### Meeting Notes

**Date: January 10, 2017**

### **Technical Team** - Meeting #6

### Full Diamond at Homestead with Connector Ramp

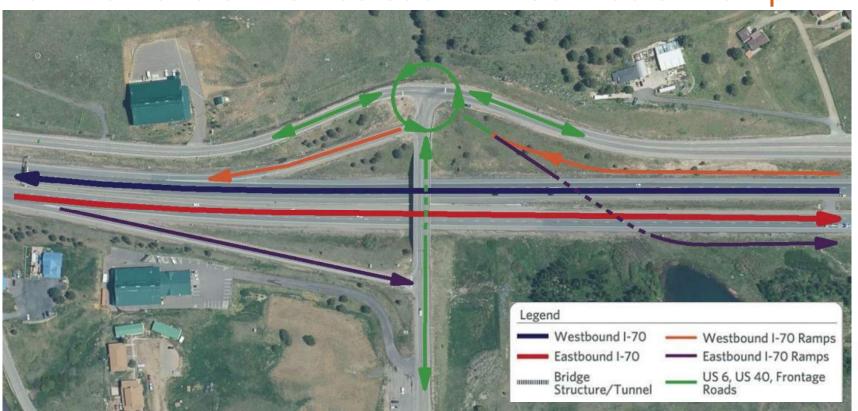
- In Option 1 (Full Diamond at Homestead) must be careful when locating roundabout as it could cause a conflict with private driveway
- Consider a roundabout for Option 1 at CR 65 (currently a full diamond)

### Half Diamond

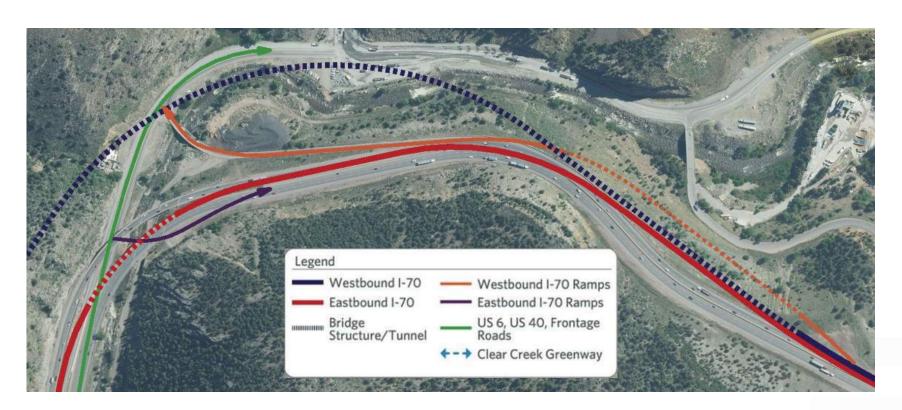
Less confusing and less visual impacts
By eliminating WB on-ramp from US 6, would eliminate those bottlenecking
Less construction impacts Option 6 half-diamond
½ diamond facilitates local industry and access
½ diamond is less circuitous
Less construction impacts
No impact at Frei – keep trucks on I-70
Doesn't limit access to US 6 and Kermitts/2 Bears

Off ramp on a bridge No access to/from Denver at US 6; out of direction travel Flyover/Half-spiral is costly and has visual impacts Interchange is confusing
